**CITY OF TEMPE
DEVELOPMENT REVIEW COMMISSION**

**Meeting Date: 01/08/2013
Agenda Item: 3**

ACTION: Request for approval of a Development Plan Review for an office addition for RISK ASSESSMENT GROUP located at 2100 South Rural Road. The applicant is Bain Architecture.

SOUTH ELEVATION
 SCALE 1/4" = 1'-0"
 0 4 8 FEET

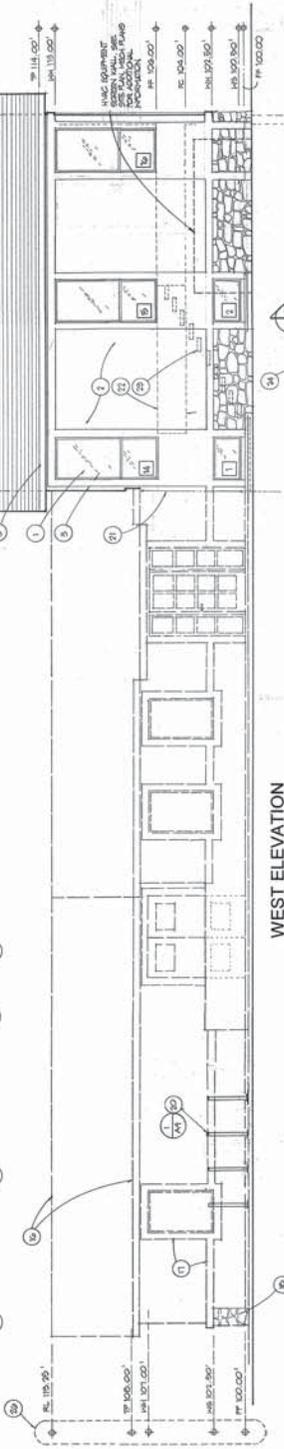
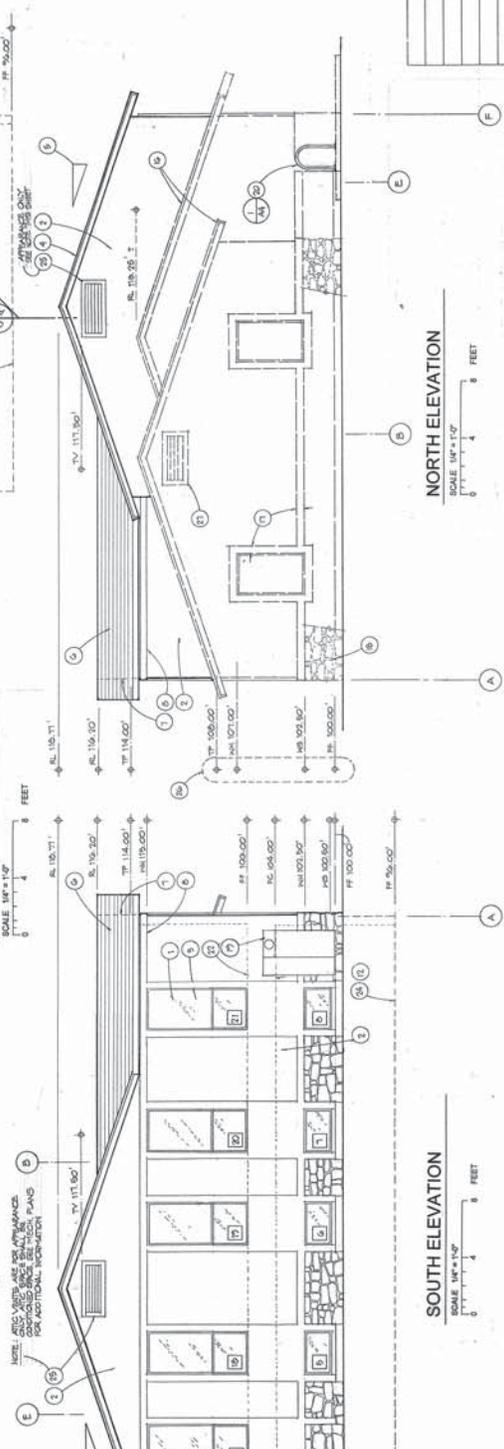
9. *Plans appropriately integrate Crime Prevention Through Environmental Design principles such as territoriality, natural surveillance, access control, activity support, and maintenance;* The addition provides appropriate crime prevention measures. Through conditions, laminated glazing is proposed for the lower level windows to prevent unauthorized entry.

1. The materials and colors are approved as presented, matching the existing building colors and stone wainscot. Additions or modifications may be submitted for review during building plan check process.
2. On the south elevation provide laminated safety glazing at the lower level windows.
3. The plant palette is approved as proposed and specified on the landscape plan. Any additions or modifications may be submitted for review during building plan check process.
4. Provide one additional tree, three in total, in conformance with the required number of street trees.
5. Provide building address numerals on the freestanding sign and near the building entrance.
